Total System Performance Assessment Supplemental Sensitivity Analyses: Igneous Activity

**DOE/NRC Technical Exchange on Key Technical Issues
Topics Related to Igneous Activity**

Biosphere-Igneous Activity Interactions

Preliminary
Igneous Event Direct Release Wind Speed Sensitivity

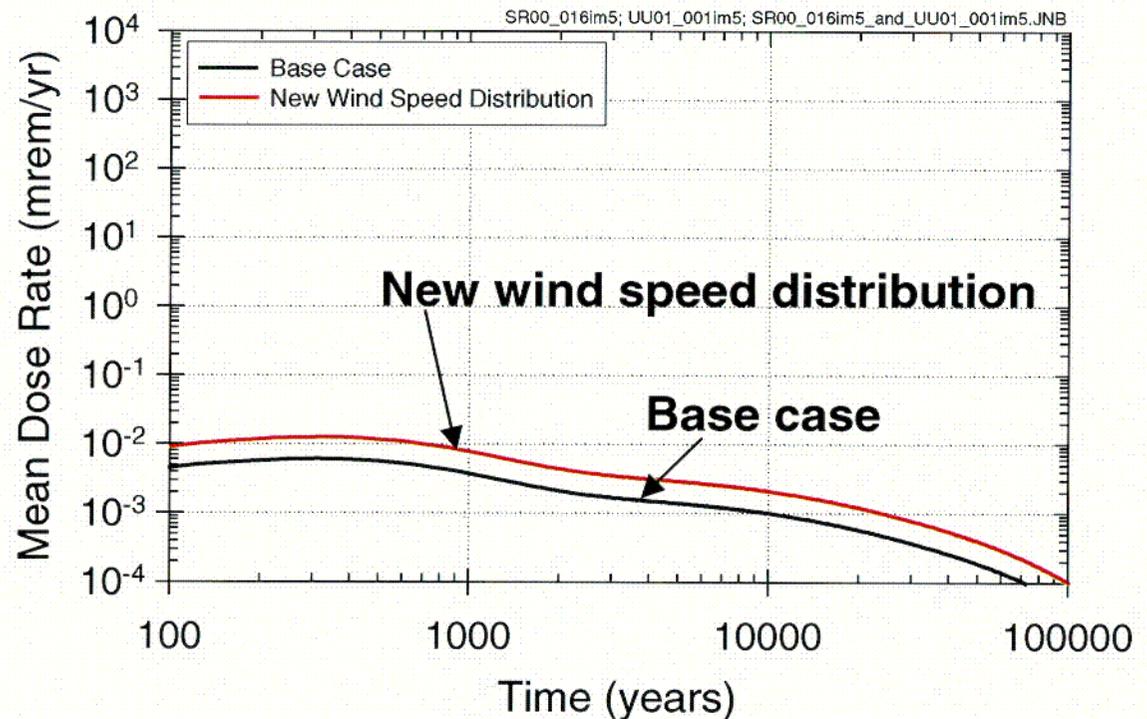
- **Issue: Discuss incorporation of new wind velocity data into the DOE TSPA model. Discuss method used to average wind velocity in TSPA models (i.e., account for time laterally advecting in plume)**
- **Basis for Resolution**
 - **TSPA-SR REV 00 ICN 01 used wind data from Quiring (1968)**
 - ◆ Data from approximately 1500 m to 5000 m above mean sea level

- **Basis for Resolution (continued)**
 - **Data from Desert Rock airstrip (NOAA n.d.) includes higher altitudes**
 - ◆ Wind speed distribution used in supplemental analyses based on 300 millibar data, (average elevation 9400 m above mean sea level)
 - ◆ Maximum speed 5683 cm/s, ~2.4X TSPA-SR REV 00 ICN 01
 - ◆ Median value 1033 cm/s, ~1.6X TSPA-SR REV 00 ICN 01
- **Conclusion: Calculated probability-weighted mean annual doses are moderately sensitive to wind speed uncertainty**
 - **New data increase probability-weighted dose ~2x**

Igneous Event Direct Release Waste Particle Size Sensitivity

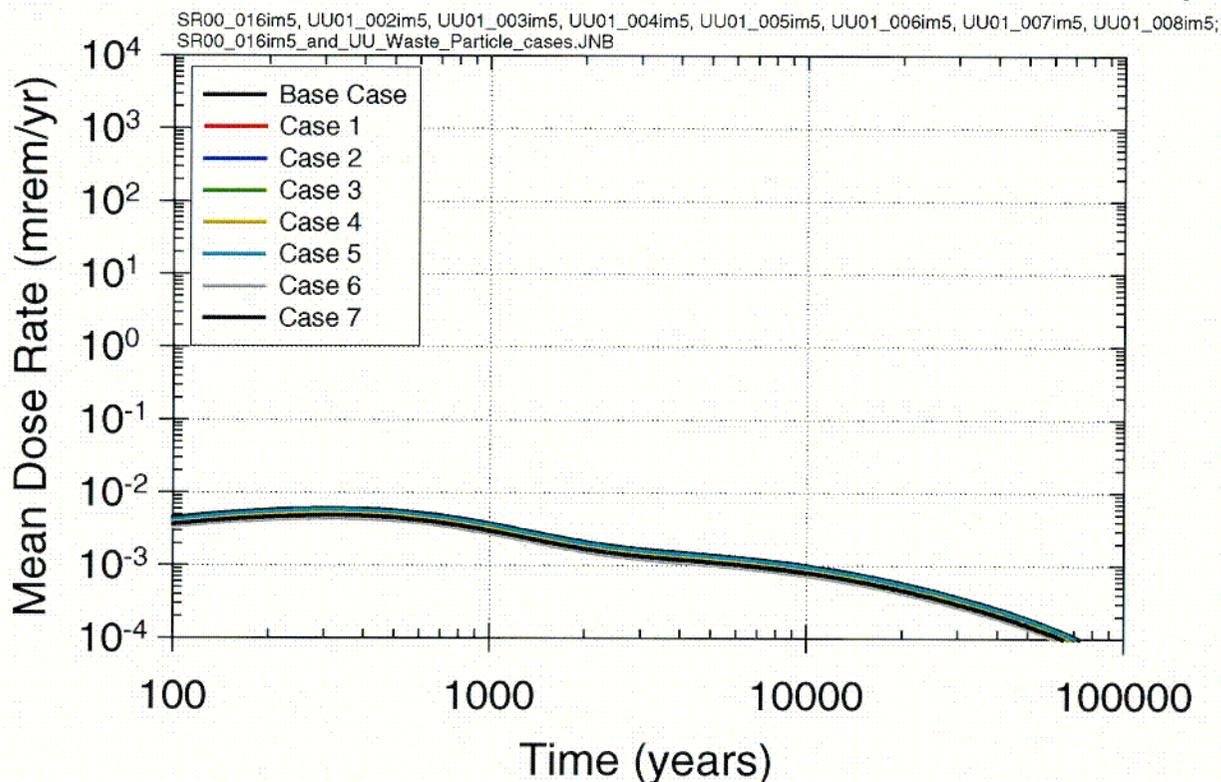
- **Issue: Document the results of sensitivity studies for particle size**
- **Basis for Resolution**
 - **TSPA-SR REV 00 ICN 01**
 - ◆ Log triangular distribution
 - ◆ Min = 0.0001 cm, mode = 0.002 cm, and max = 0.05 cm
 - **Supplemental sensitivity analyses (work in progress)**
 - ◆ Minimum decreased by factor of 2, maximum increased by a factor of 2, mode varied over a range from 1/10 to 10x the base case
- **Total of 7 cases**
- **Conclusion: Calculated probability-weighted mean annual doses are insensitive to uncertainty in waste particle diameter within this range (0.00005 to 0.1 cm, modes between 0.0002 and 0.02 cm)**

Relative Contributions to Calculated Annual Dose from Zone 1 and Zone 2

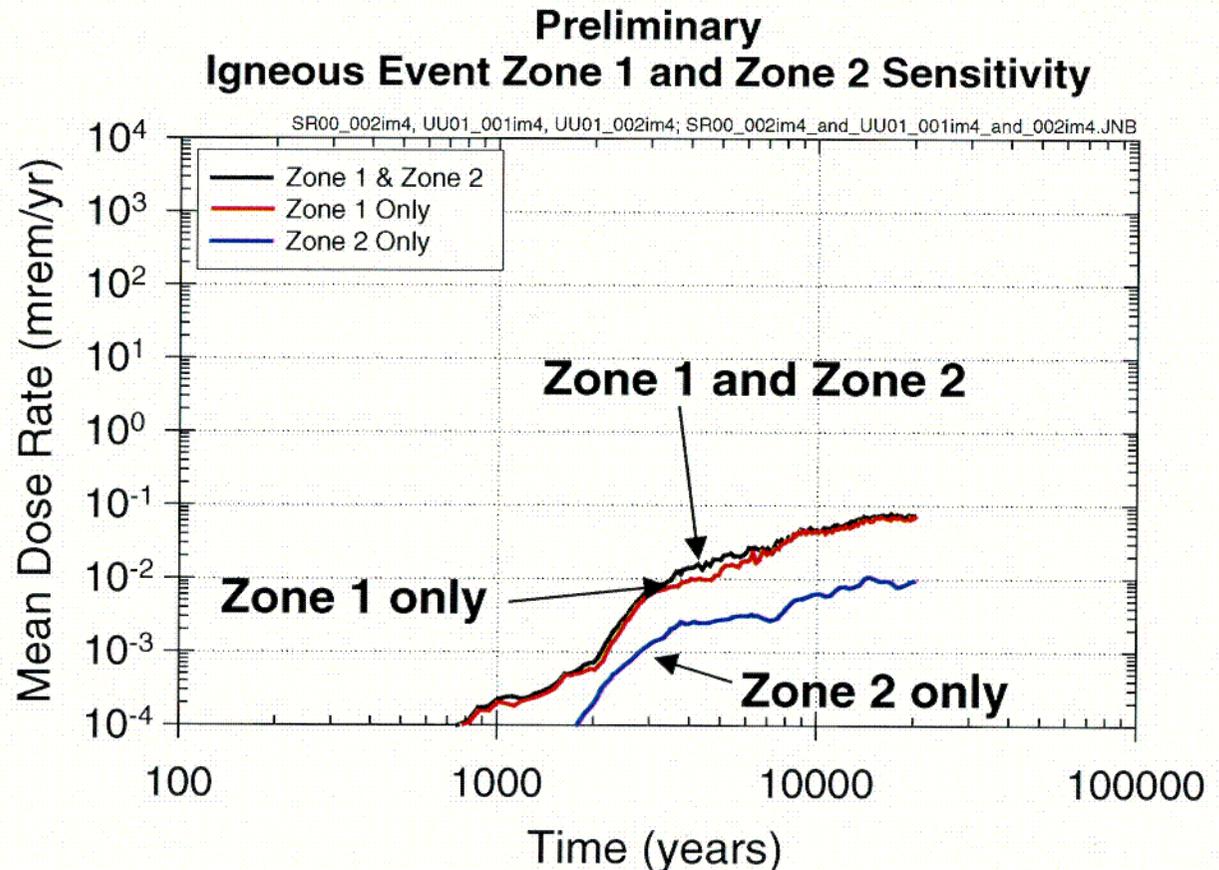
- **Issue: Provide results showing the relative contributions of releases from Zones 1 and 2**
- **Basis for Resolution**
 - **Zone 1 and Zone 2 are used to characterize damage to waste packages from igneous intrusion; doses occur by the groundwater pathway**
 - **Zone 1 packages are close to point of intrusion and assumed sufficiently damaged that they provide no further protection for the waste**
 - **Zone 2 packages are the remainder of packages in all intruded drifts and are assumed to be breached with an aperture of uncertain area (truncated log-normal distribution, 1 cm² to 1.9x10⁴ cm², mean = 10 cm²)**
- **Conclusion: Zone 1 is the major contributor to igneous groundwater dose**

Igneous Case
Non-Probability Weighted Direct Release Mean Dose Time Histories

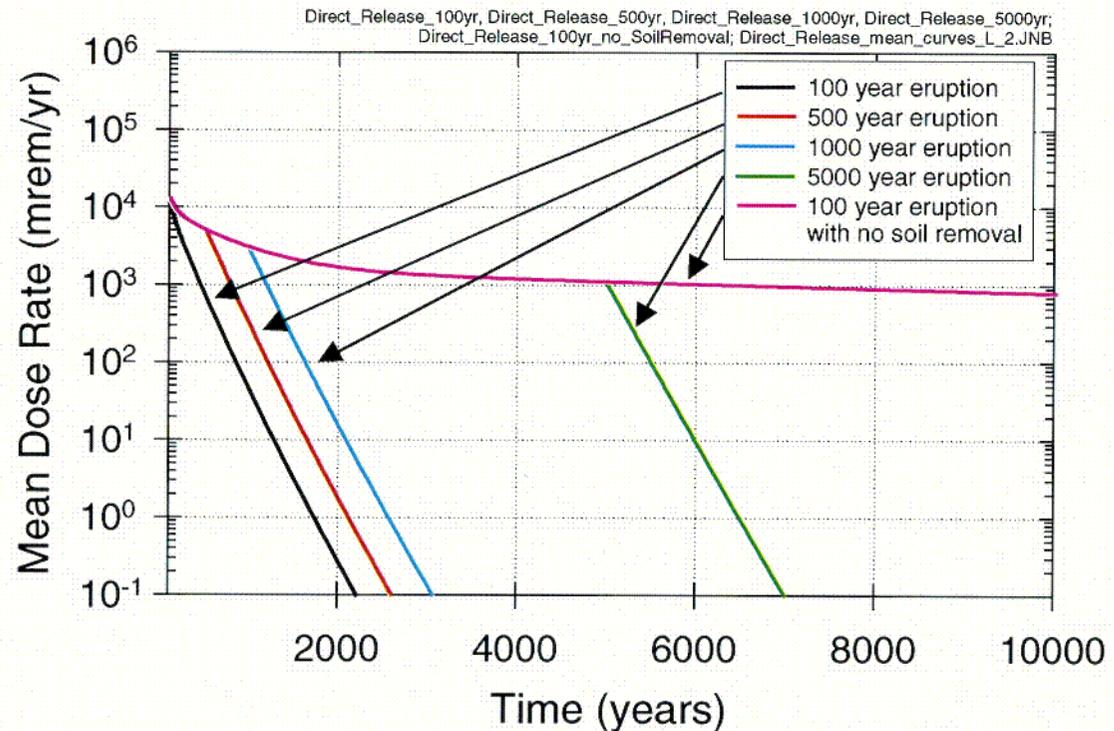
- **Issue: Develop a technical basis to support conclusions that the effects of eolian and fluvial remobilization are bounded by conservative modeling assumptions in the TSPA-SR REV 00 ICN 01. Demonstrate how more realistic models account for:**
 - i) rate of mobilization off slopes
 - ii) rate of transport in Fortymile Wash drainages
 - iii) rate of transport from eolian processes
 - iv) deposition rate at proposed critical group location
 - v) changes in particle-size distributions during fluvial transport**would not lead to higher calculations of risk**

- **Conclusion:**
 - **For the same set of input parameters, conditional dose at any time following an eruption can be no greater than the dose that would result if the eruption occurred in that year (i.e., doses don't get worse than they are in the first year)**
 - **Given the conservative approach to the transition BDCFs (i.e., concentrating radionuclides in the upper 1 cm and assuming high air mass loading), conditional eruptive doses with no soil removal bound surface redistribution effects**
 - **Assumes concentrations do not increase during redistribution**
 - **DOE considers that this approach provides a technical basis to demonstrate that the modeling assumptions in TSPA-SR REV 00, ICN 01 are conservative**
